Response to Reviewer #2's comments:

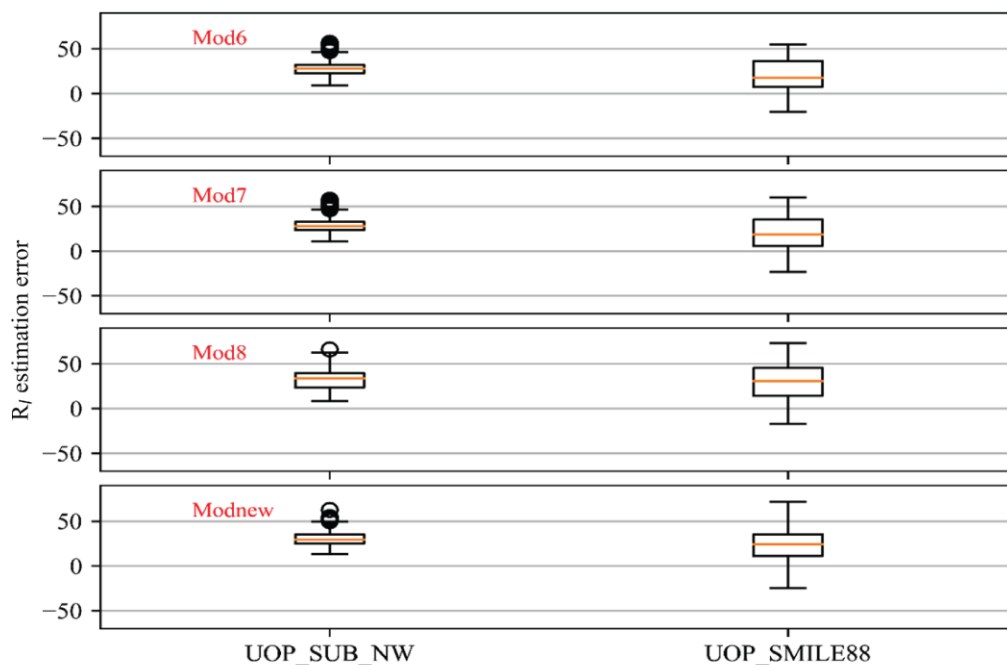
Figure 11. Could you make the y-axis labeling more concise so that it is legible? Also please define what the different levels are in the box plots.

We have fixed the Figure 11. The top edge, center, and bottom edge of the box represent the 75th, 50th (median), and 25th percentiles, respectively. The whiskers indicate the maximum and minimum values within 1.5 times the interquartile range (IQR), and the circles denote outliers.
